**King's Mark
Environmental
Review
Team
Report**

**LITCHFIELD HILLS MALL
TORRINGTON,
CONNECTICUT**

Environmental Review Team Report

Torrington Inland Wetlands Commission

PROPOSED SITE PLAN

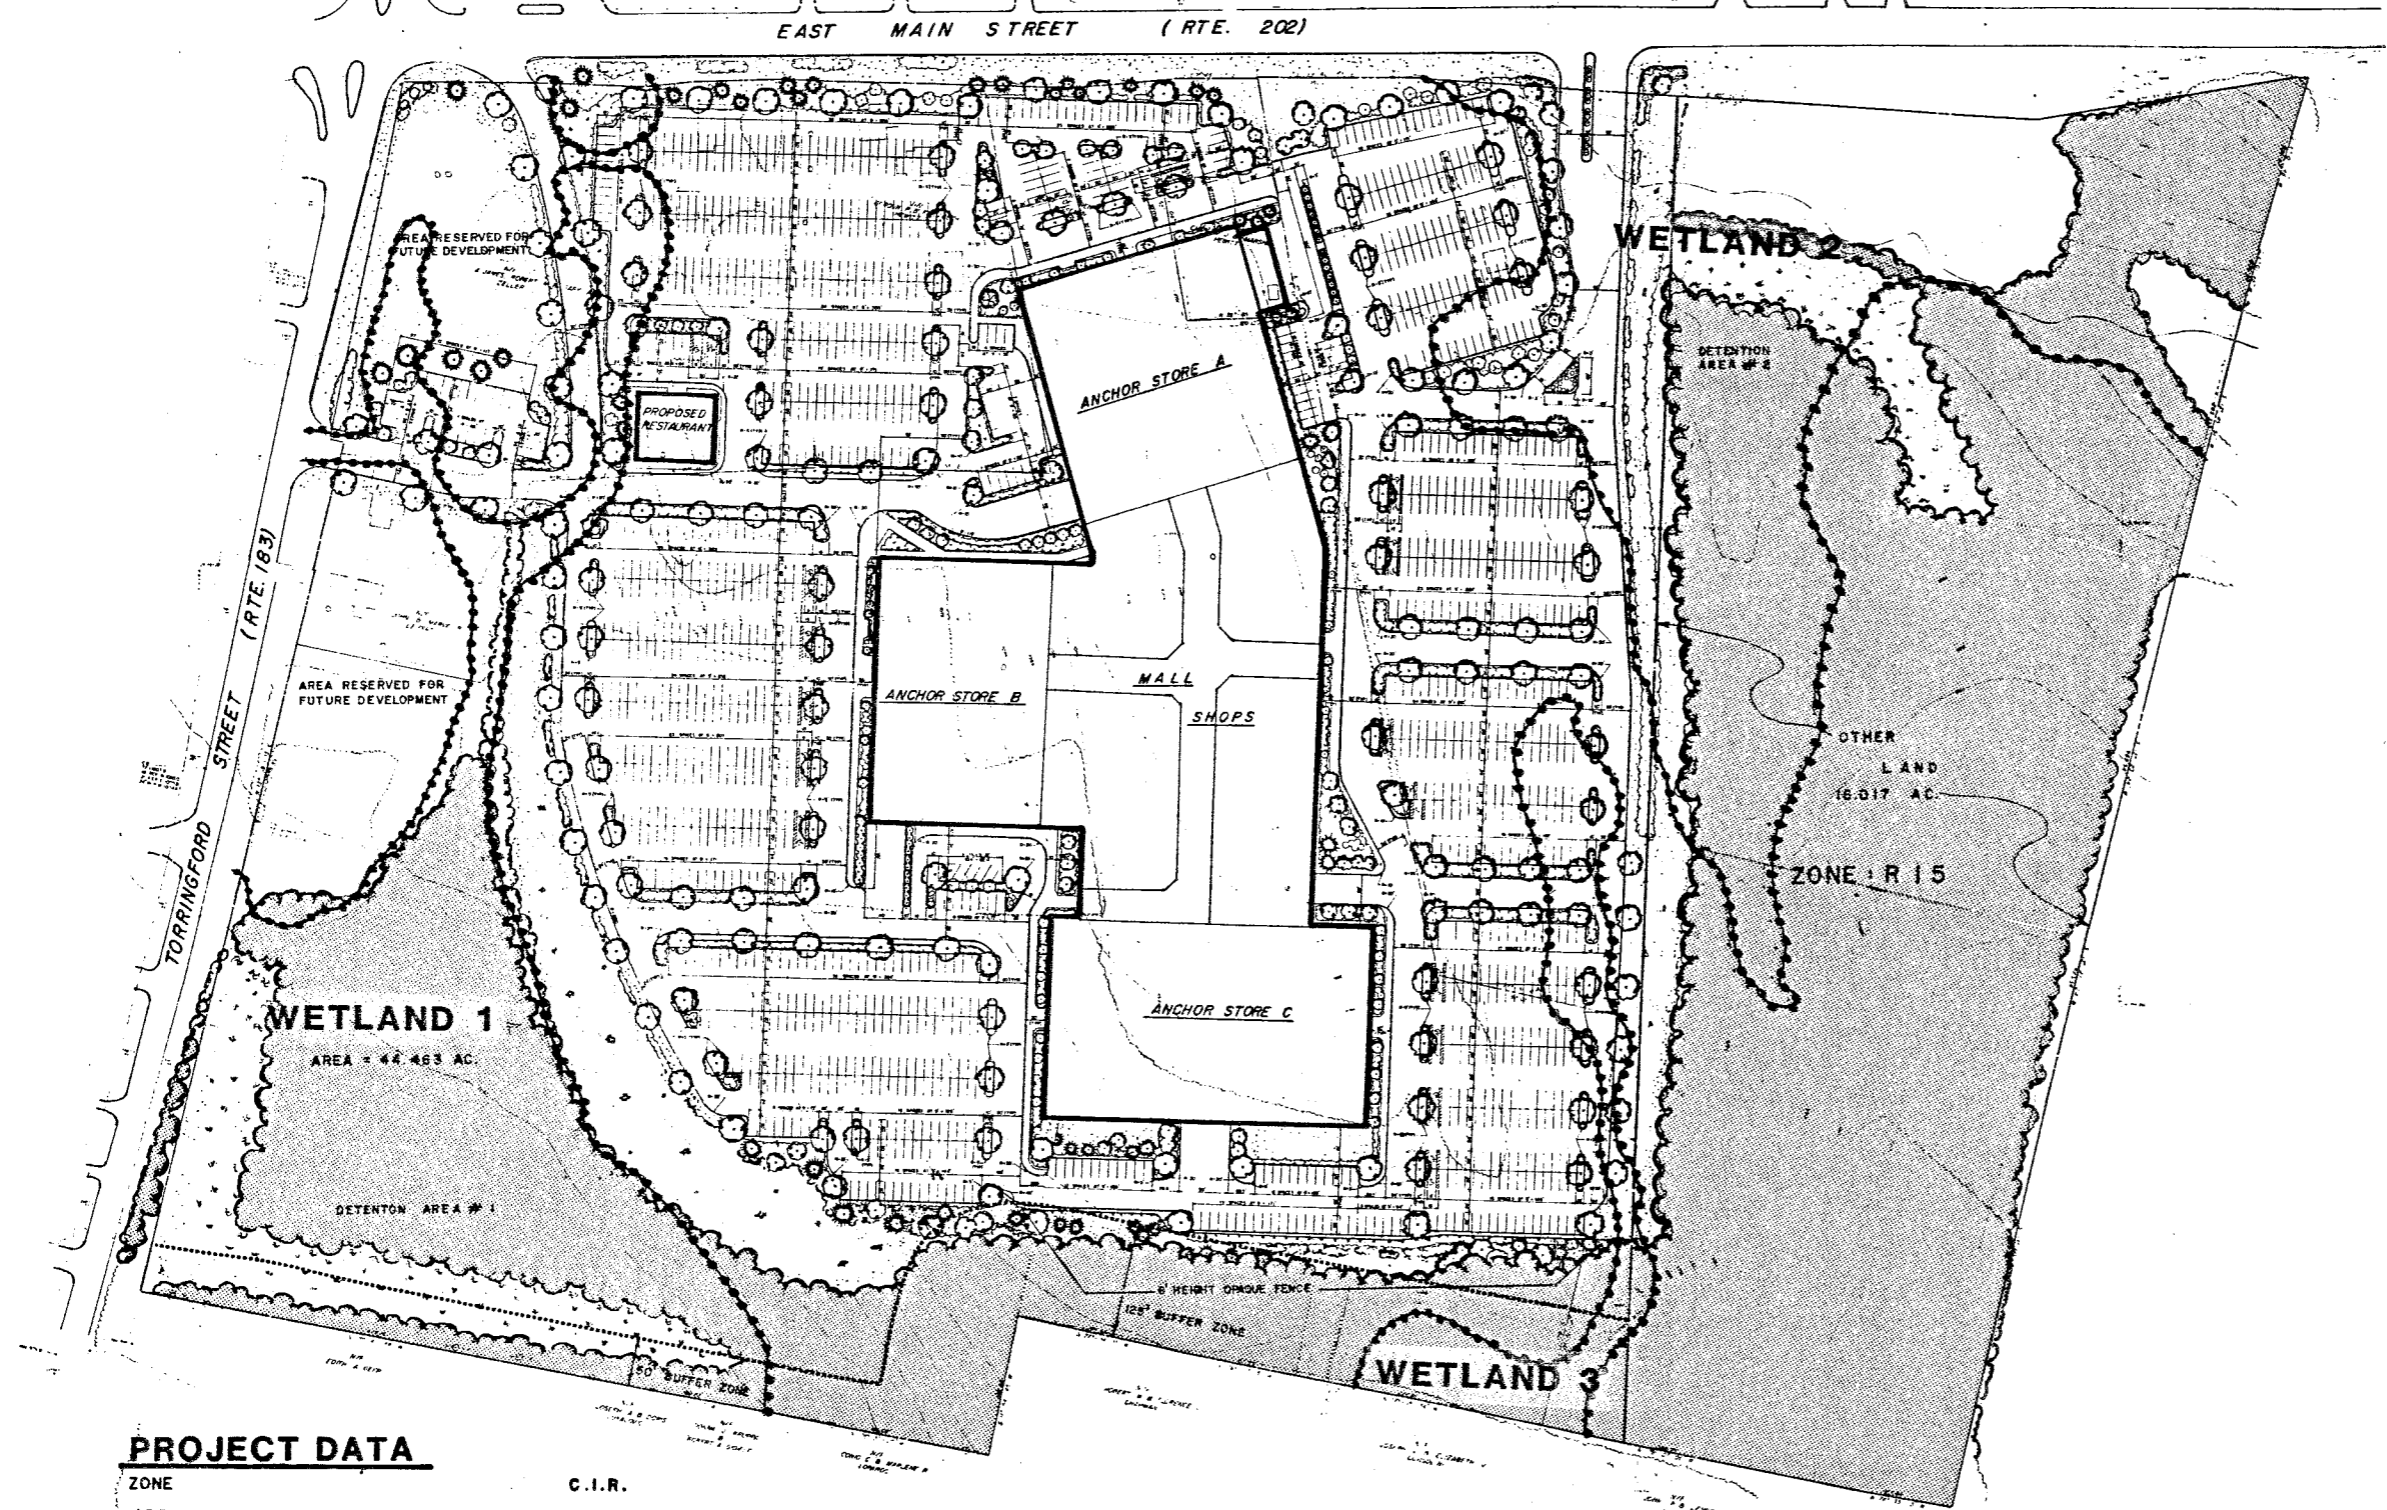
The "clearing limits of disturbance" shown on the plans coincide with the wetland limits at the base of the slope. Because of the large amount of earth moving proposed and the limitations of this area, the schematic is not realistic, and work will certainly extend into the wetlands area.

An erosion and sediment (E&S) control plan has been provided for the proposed development. The following comments/recommendations for this E&S plan are listed by sheet number.

Sheet S-1

1. Trench drain #69 is shown as the outlet to one section of the drainage system. No detail for this trench drain was included. If this drain is to percolate water into the ground it should be noted that these soils typically have very slow perc rates. An alternative outlet for this water should be investigated.
2. The plunge pool shown in the northeast corner of this sheet has no outlet. This drainage outlet needs to be clarified. The high groundwater table of the wetland soil at this plunge pool is likely to be saturated much of the year, limiting percolation of drainage water into the ground.
3. The silt fence should be moved below the fill in the wetland on the western side of sheet S-1.

Sheet S-2

1. Rip-rap may be needed to stabilize the proposed channel through the detention basin.

Sheet S-3

1. Filter fence is needed along the east side of the proposed land filling.
2. Two drains are proposed to outlet on the fill slope on the east edge of the land grading. The drainage pipe should be extended at least to the toe of the proposed slope.
3. Trench drain #88 is shown as the outlet to one section of the drainage system. See comment on sheet S-1.

- (2) The southwest corner of the proposed parking area will have a 50 foot drop off at its edge, with a 2 to 1 slope. The toe of this proposed embankment directly borders the wetlands. This hillside, composed of the till taken from the drumlin, poses several potential problems to the wetlands. First, the proposed 2 to 1 slope will be highly susceptible to erosion in the first few months of its creation. This could result in high amounts of sediment pollution within the wetland. If severe sedimentation were to occur it could also influence the holding capacity of the proposed detention basin in that area. An embankment with a slope of 3 to 1 or more is preferred, while further encroachment into the wetlands should be avoided.
